HumeLink

Amendment Report

Rev 0

May 2024

FIGURE 3-1: Green Hills corridor amendment

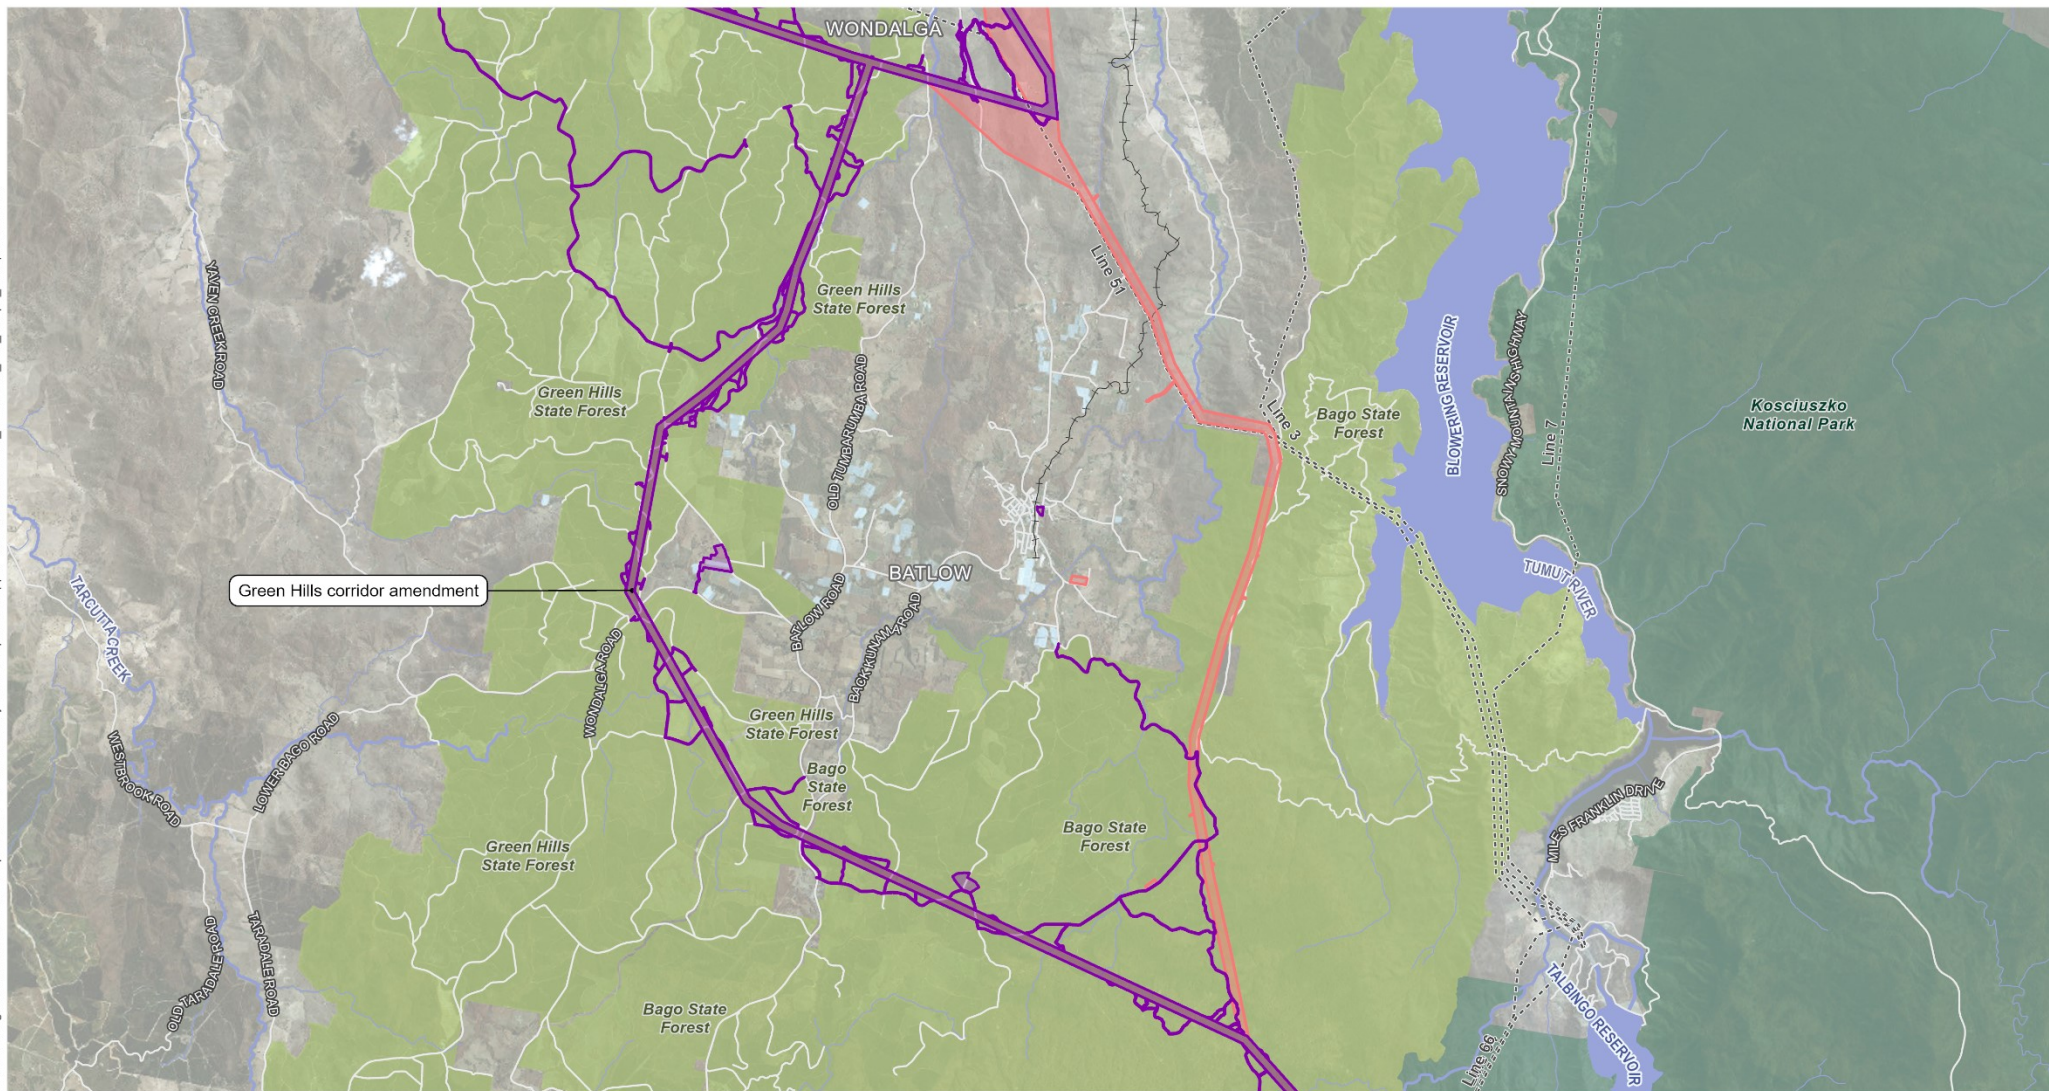
Section 3.3.1.3 of the EIS provided an overview of the transmission line corridor between Wondalga and the future Maragle 500 kV substation. The transmission line corridor generally ran in a south-south-east direction from Wondalga before connecting with the future Maragle 500 kV substation. The transmission line corridor alignment was located to the east of Batlow and traversed private property through Wondalga and Gilmore for around 11 kilometres before traversing Bago State Forest and connecting to the future Maragle 500 kV substation.

FIGURE 3-2a: Minor changes to transmission line corridor

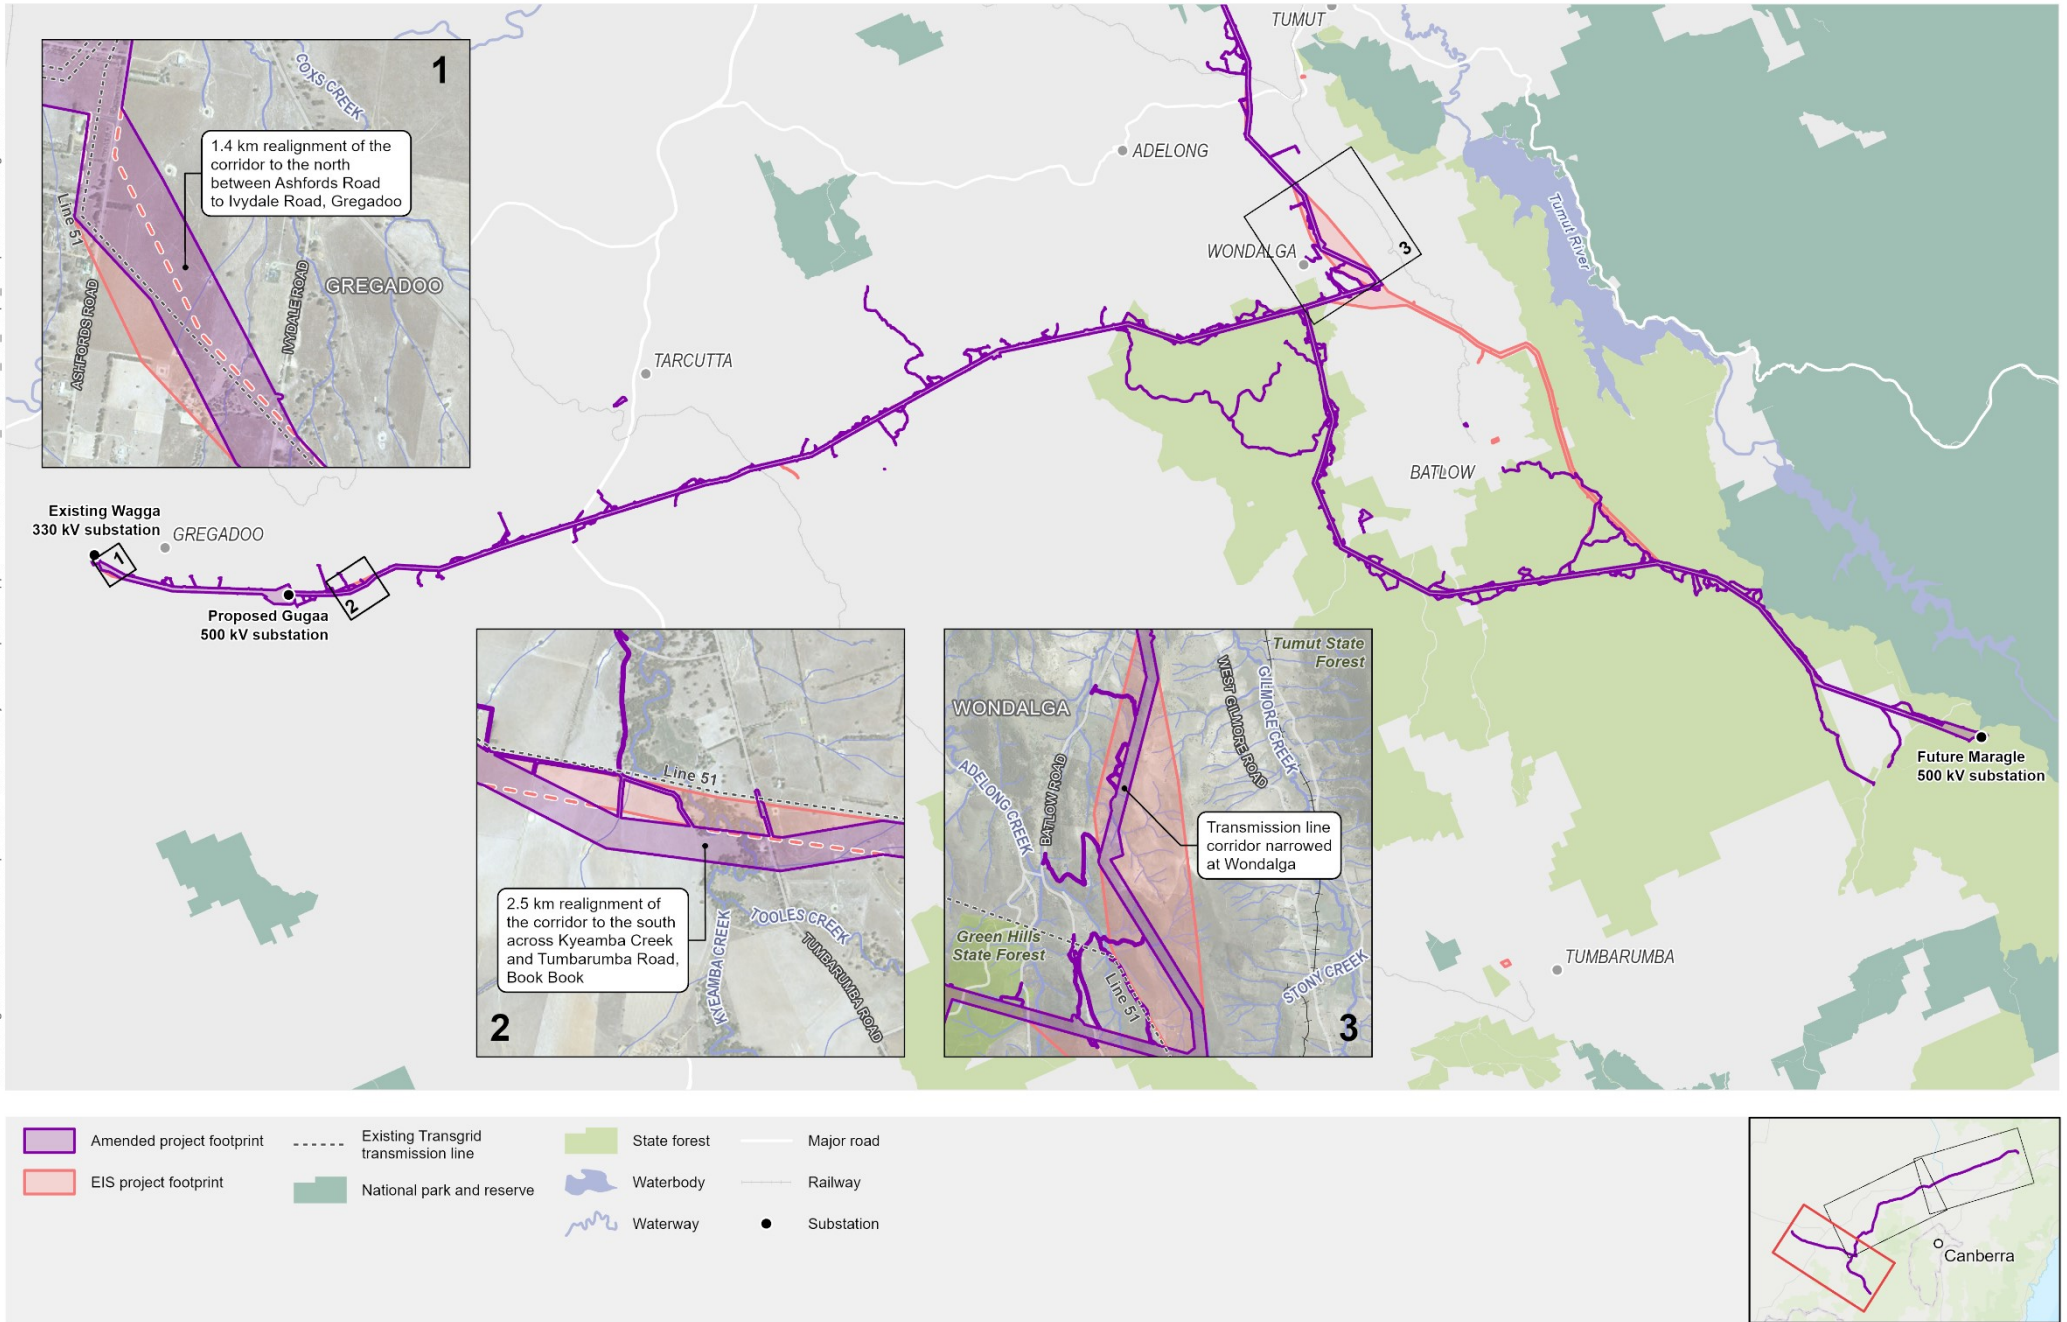
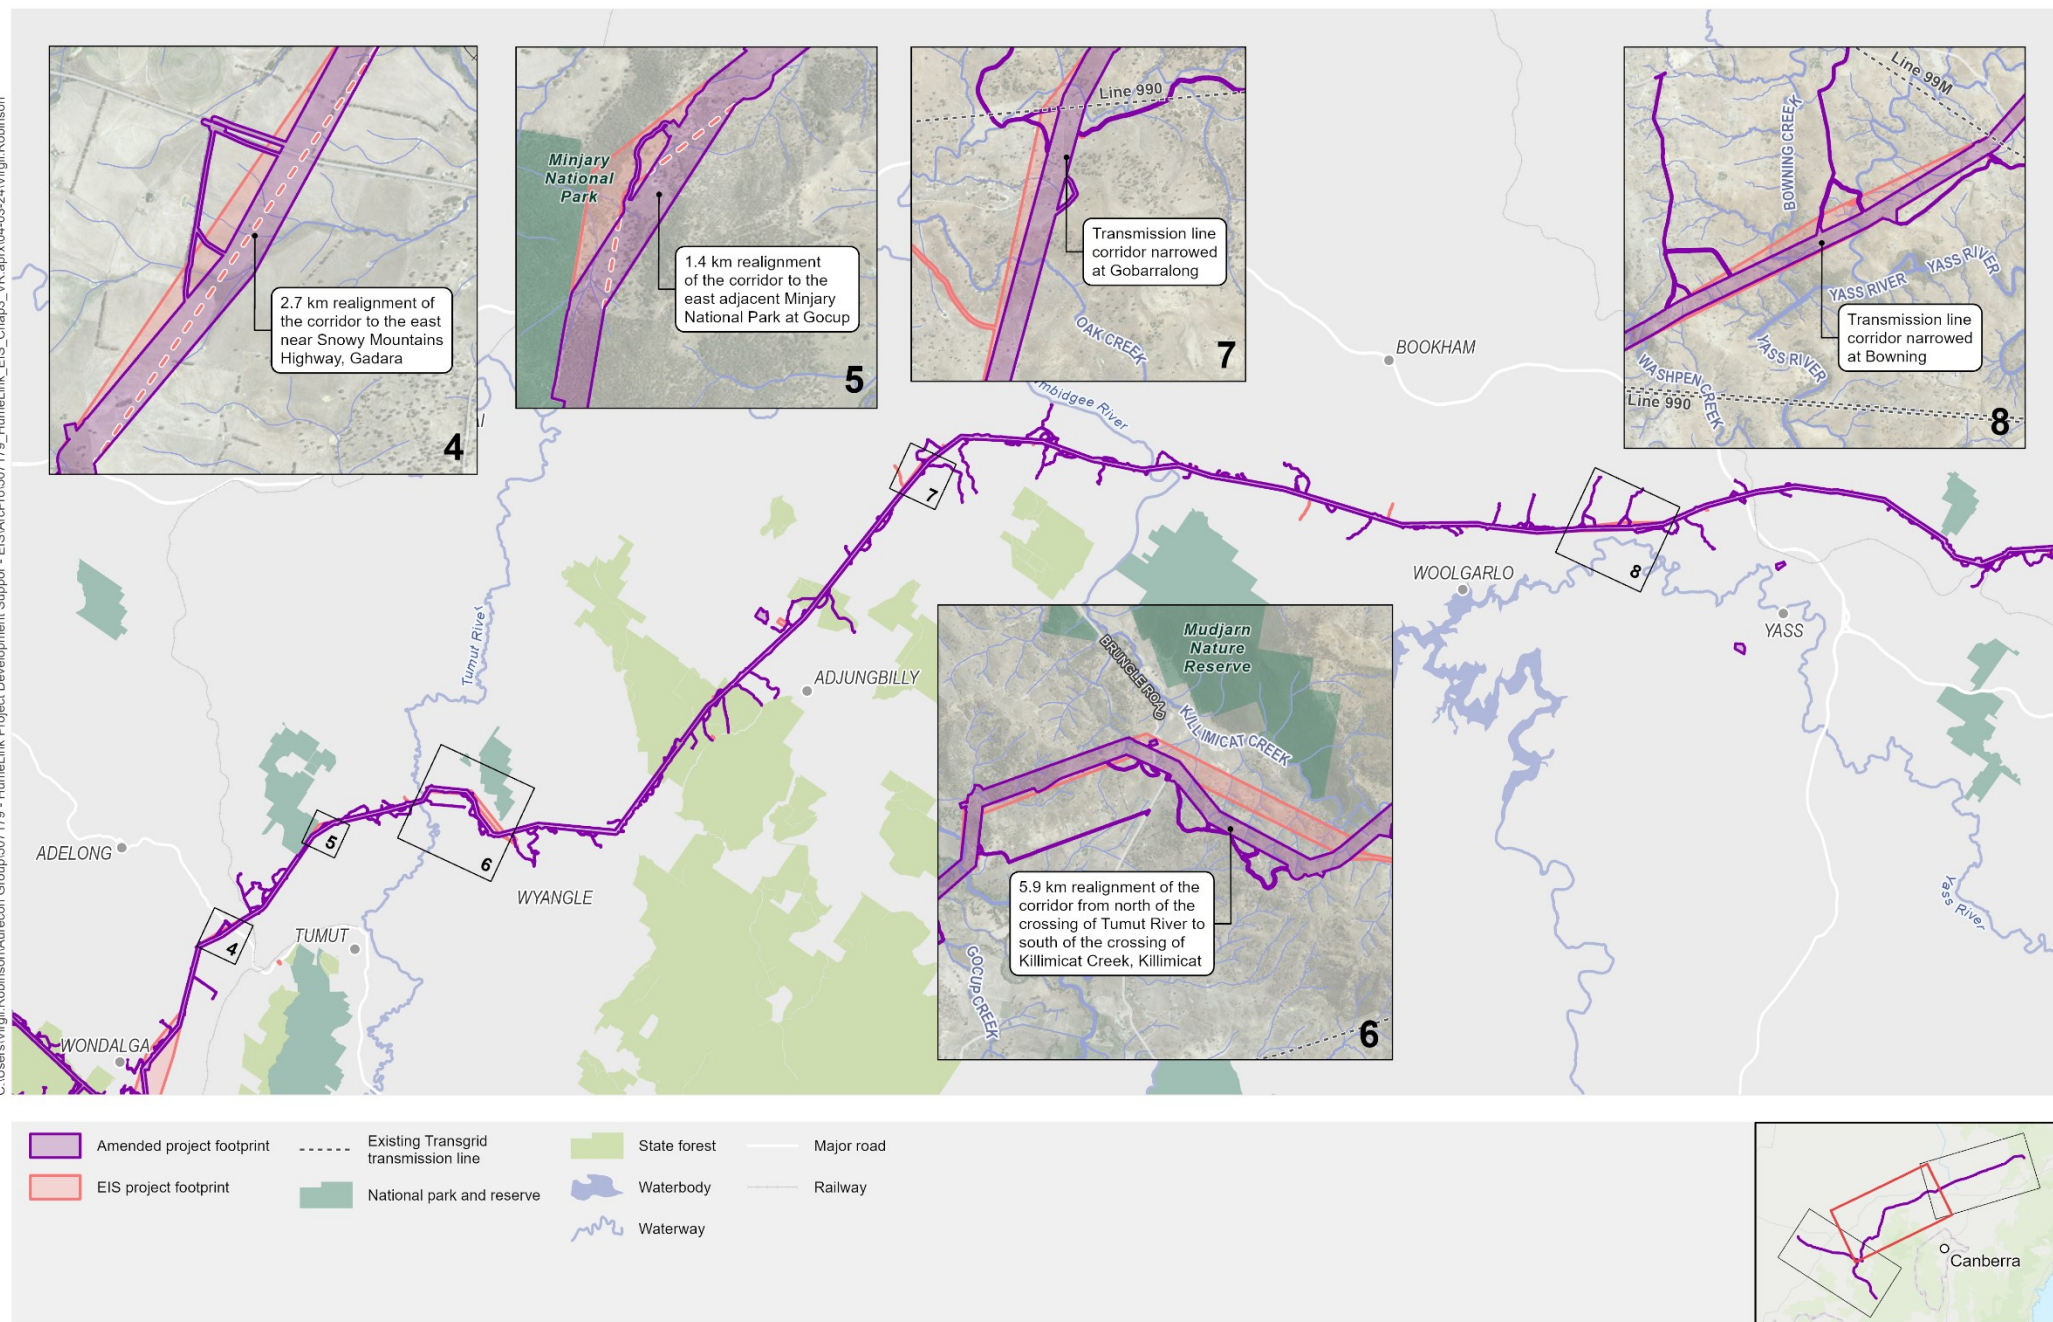
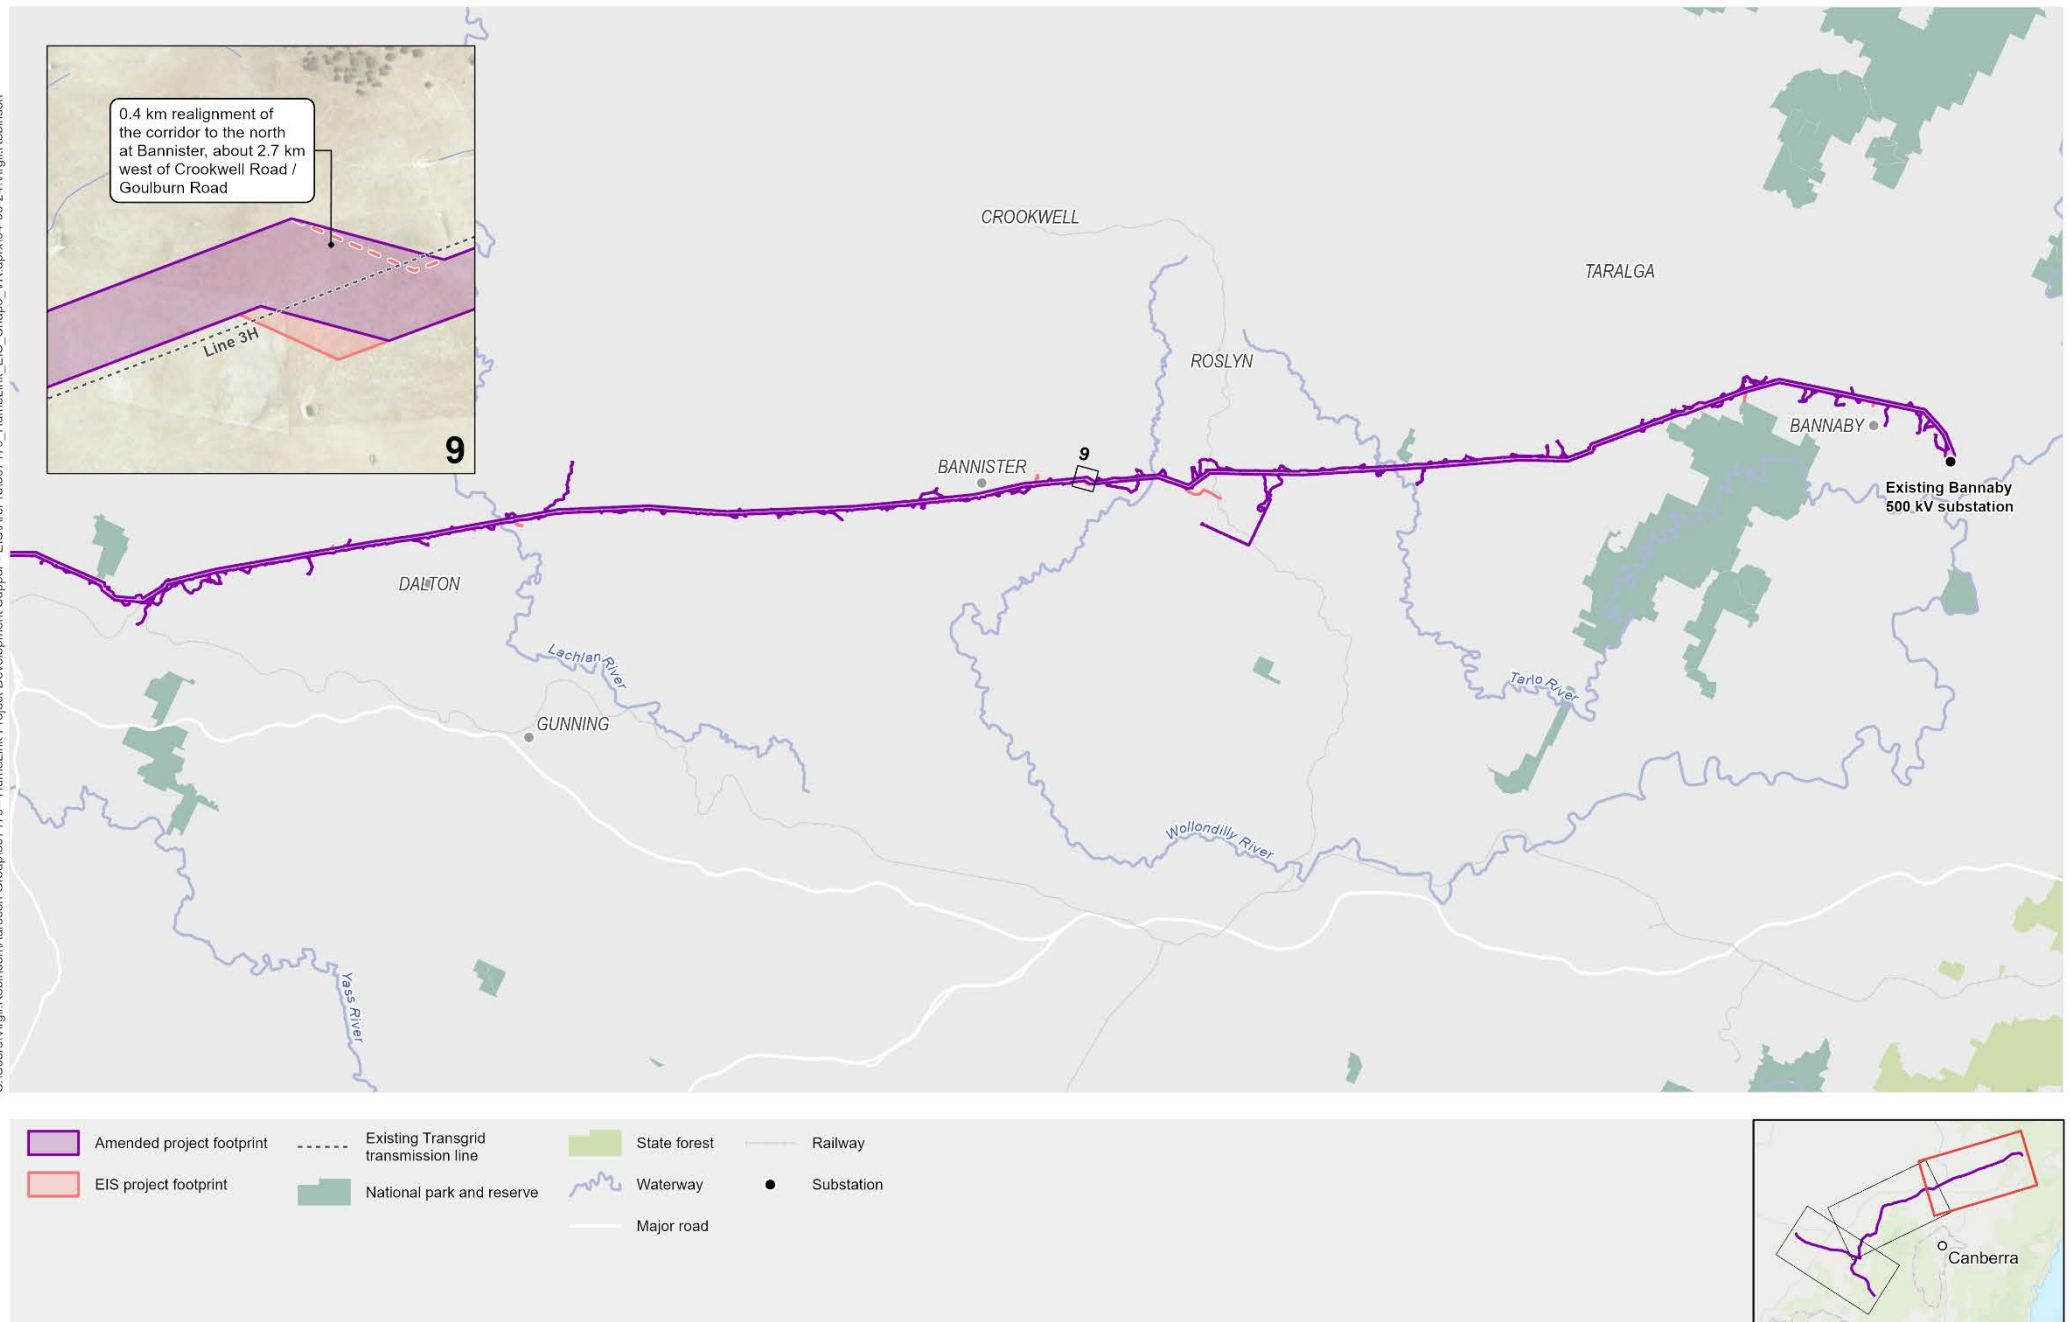
Table 3-2 provides a description of the proposed minor changes to the transmission line corridor and associated EIS project descriptions. Figure 3-2 provides a comparison of these changes and the EIS project.

General location	EIS description	Amendment description
(9) West of Crookwell Road/Goulburn Road at Bannister	From the south, the transmission line corridor extended in a north-east direction and generally paralleled an existing 330 kV transmission line (Line 3H). At about 2.7 km west of Crookwell Road/Goulburn Road, the transmission line corridor deviated from paralleling Line 3H on its northern side to be located on its southern side as it crossed Crookwell Road/Goulburn Road.	<p>Following further design development, which resulted in a reduction in transmission line structures, and subsequent supporting technical and environmental assessment to determine feasibility, a 0.4 km realignment of the transmission line corridor to the north is proposed.</p> <p>The realignment occurs at the location where the transmission line corridor deviates from paralleling Line 3H on its northern side to be located on its southern side.</p>
